**PALEN SOLAR POWER PROJECT (09-AFC-7)
CEC STAFF DATA REQUESTS 104 - 168**

Technical Area: Cultural Resources (AFC Section 5.4)

Response Date: January 6, 2010

Figure DR-CR-105-a
Figure DR-CR-105-b
Figure DR-CR-105-c
Figure DR-CR-105-d

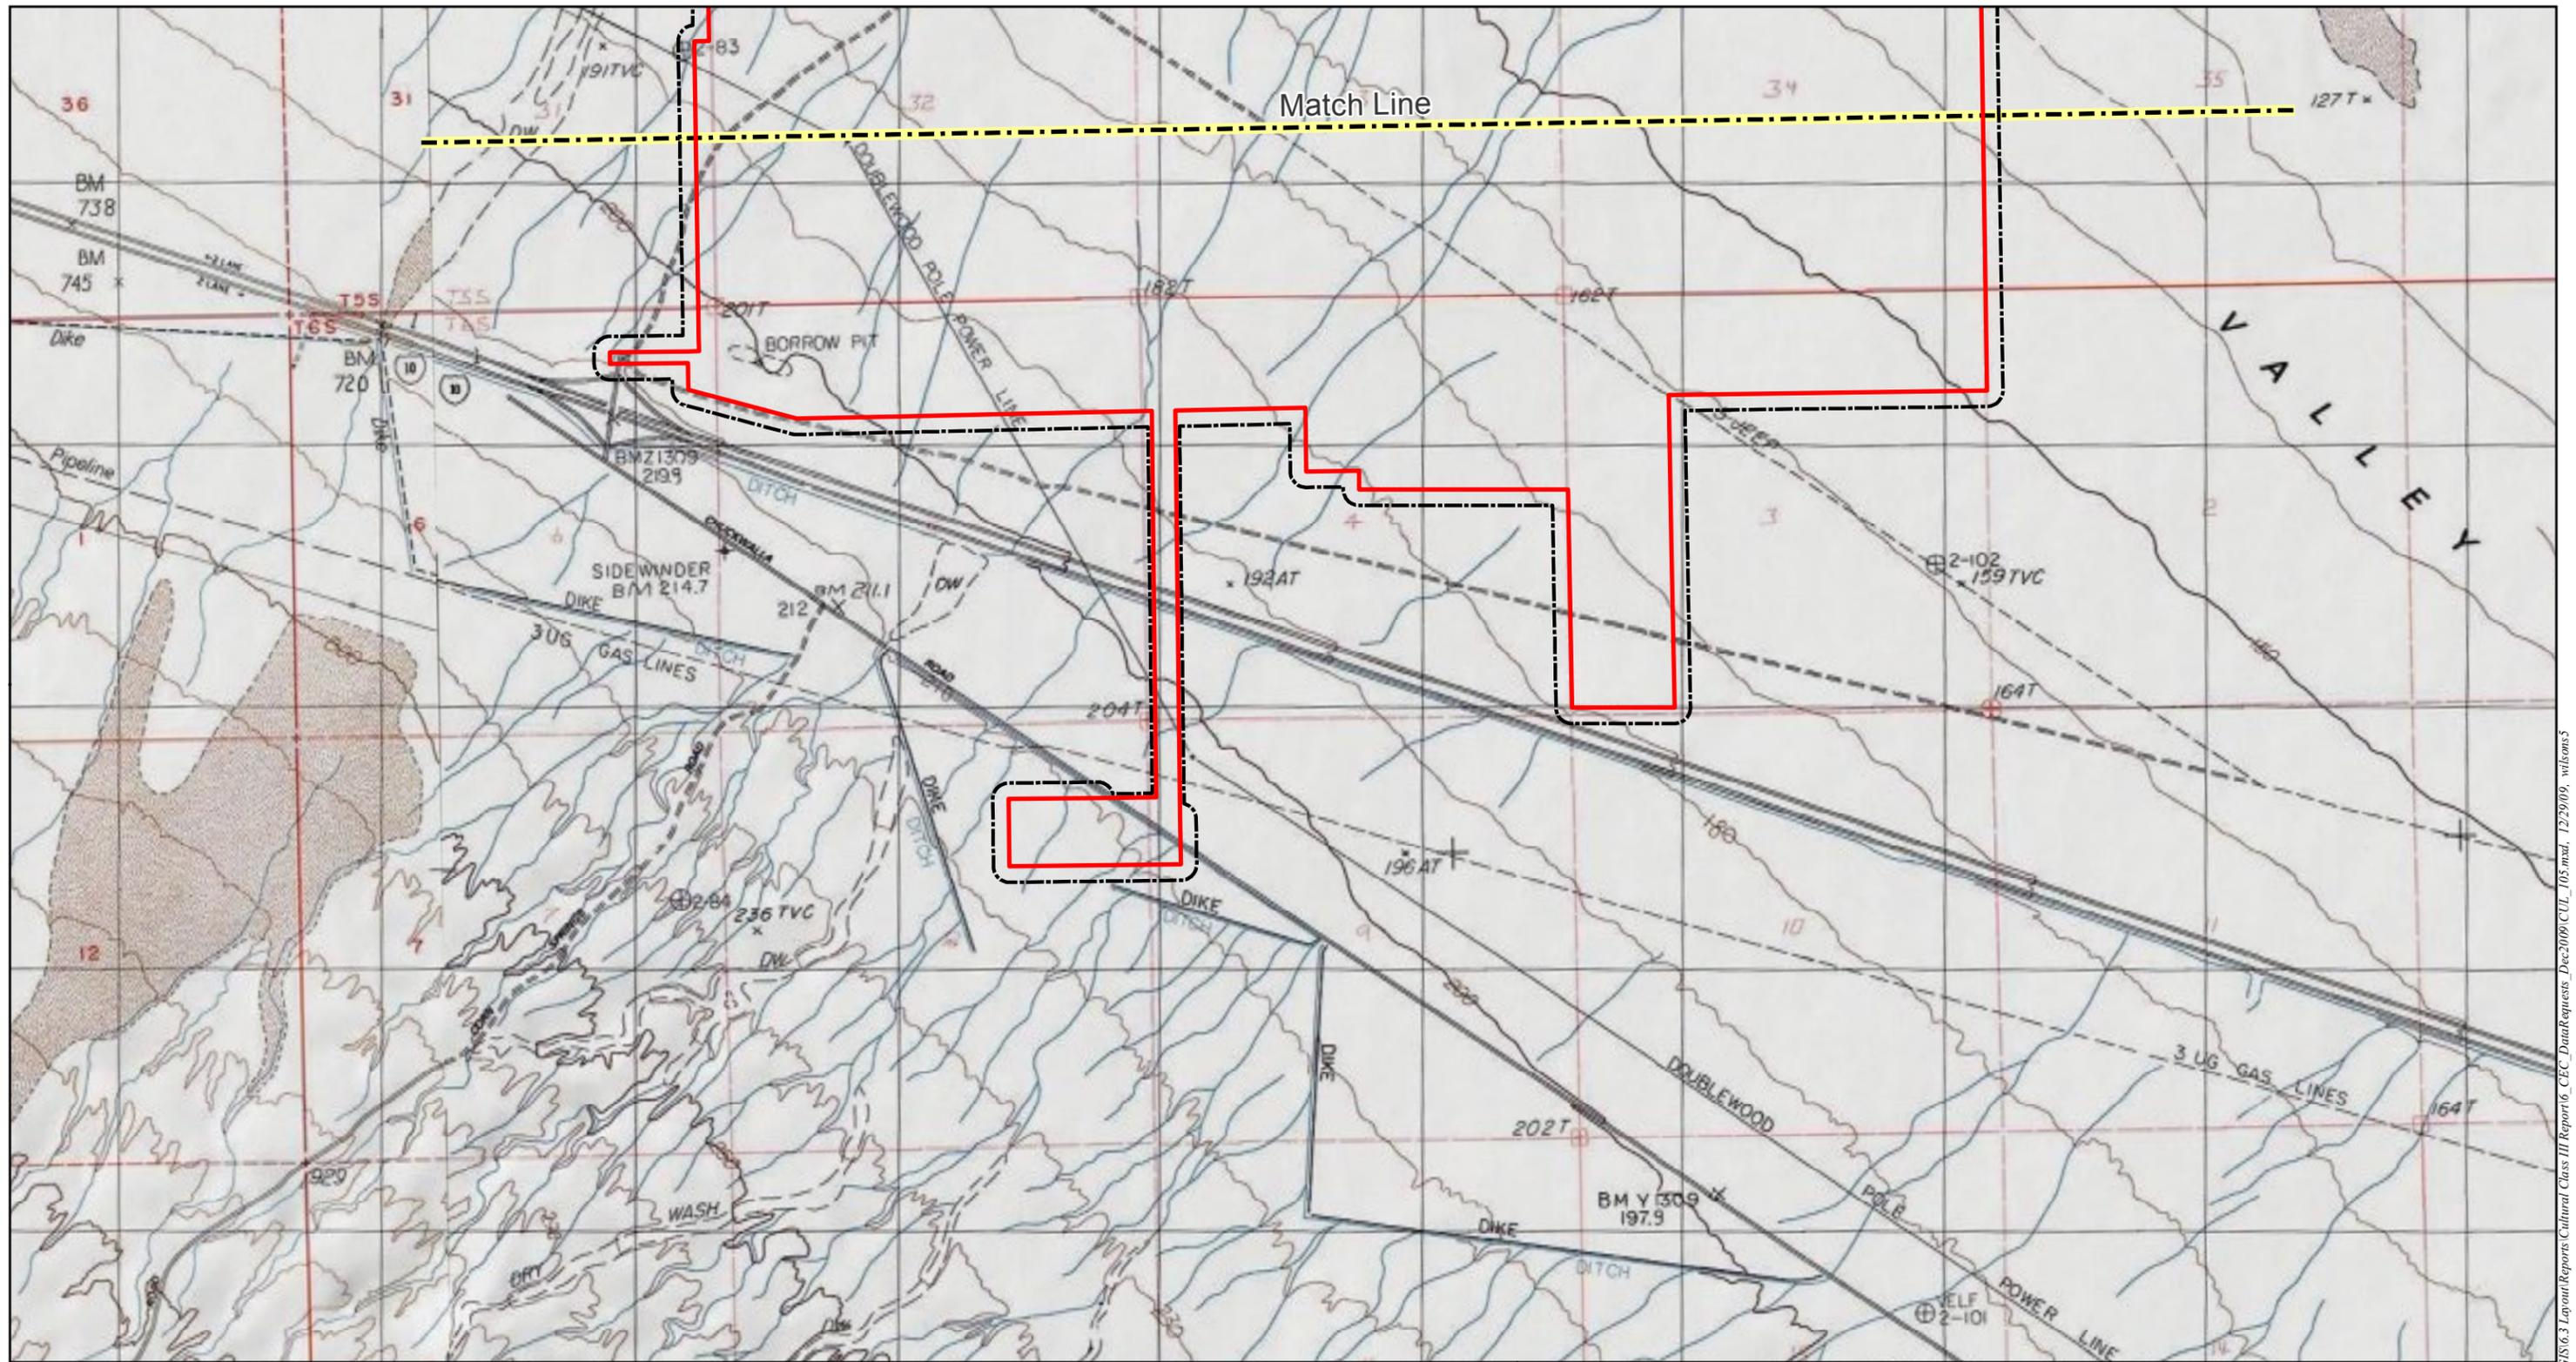
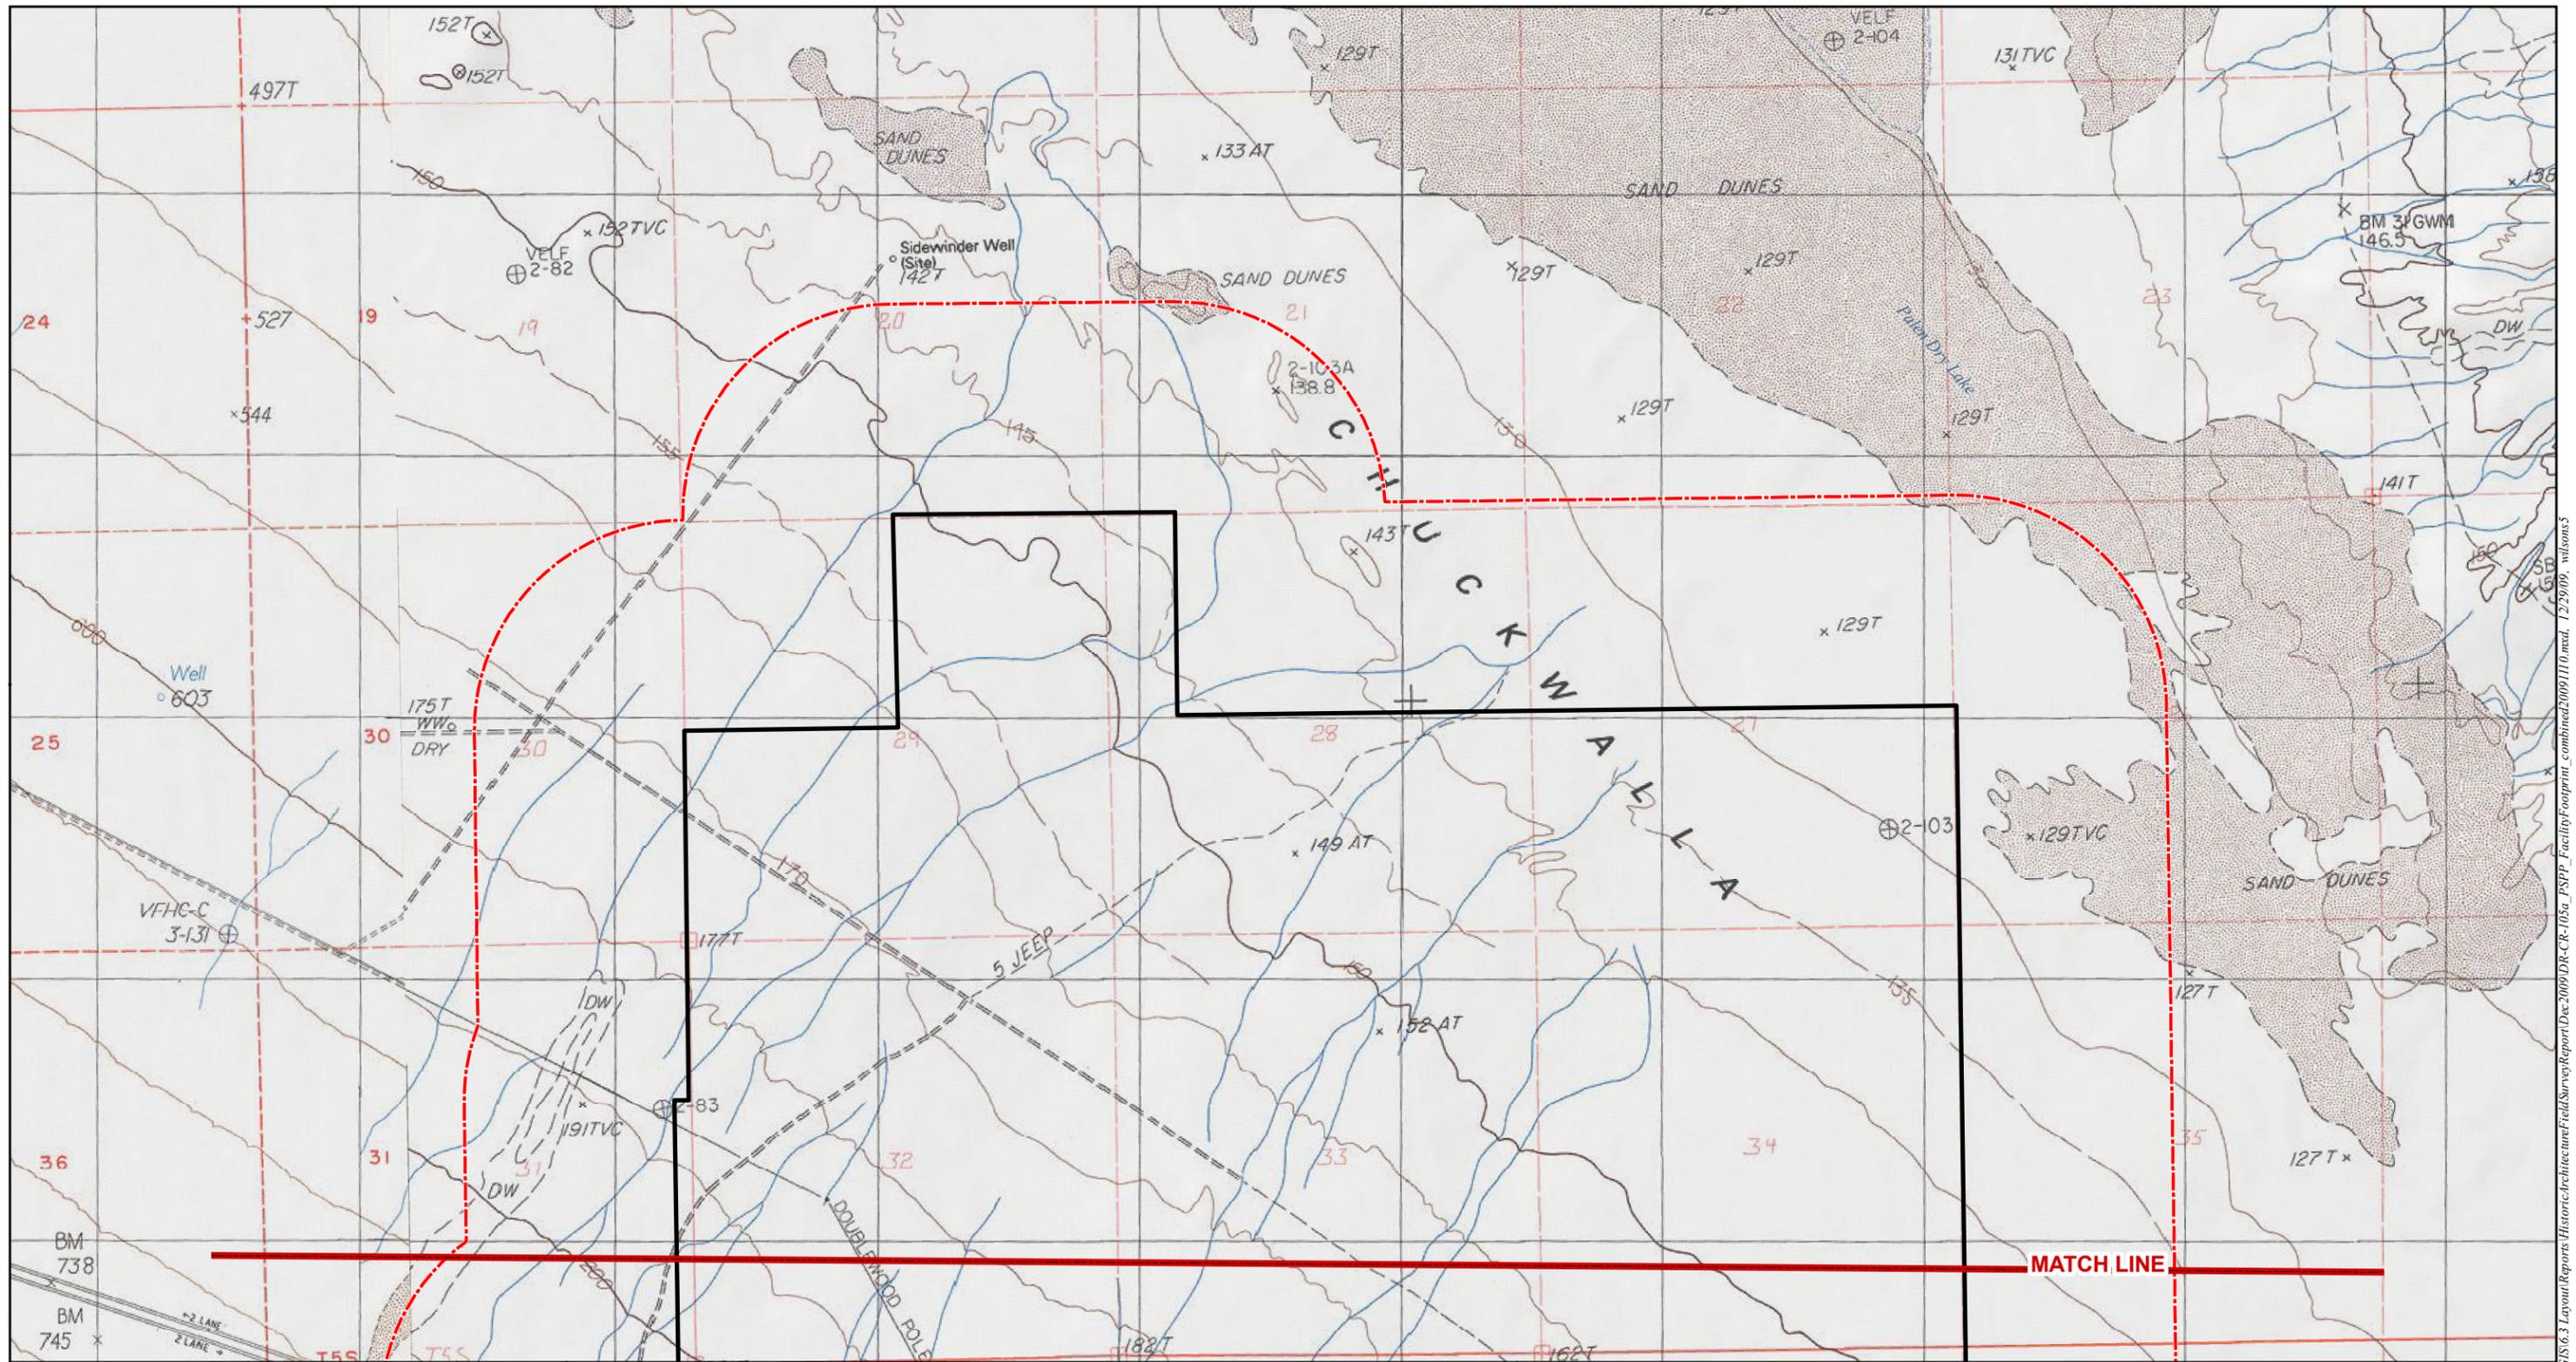
Please provide a map at a scale of 1:24,000 depicting the final and definitive archaeological surface and built-environment APEs for the proposed project.

The Area of Potential Affect (APE) is 3,946 acres. This does not include the additional CEC-mandated buffers, which are another 338 acres.

The Built Environment Survey Area is also located on the Sidewinder Well. Specifically, the Built Environment Survey Area is located in all the areas and acreages listed for the Archaeological Survey Area. The APE for the Built Environment Survey Area is 3,946 acres. This does not include the additional CEC-mandated buffers, which are another 5,027 acres.
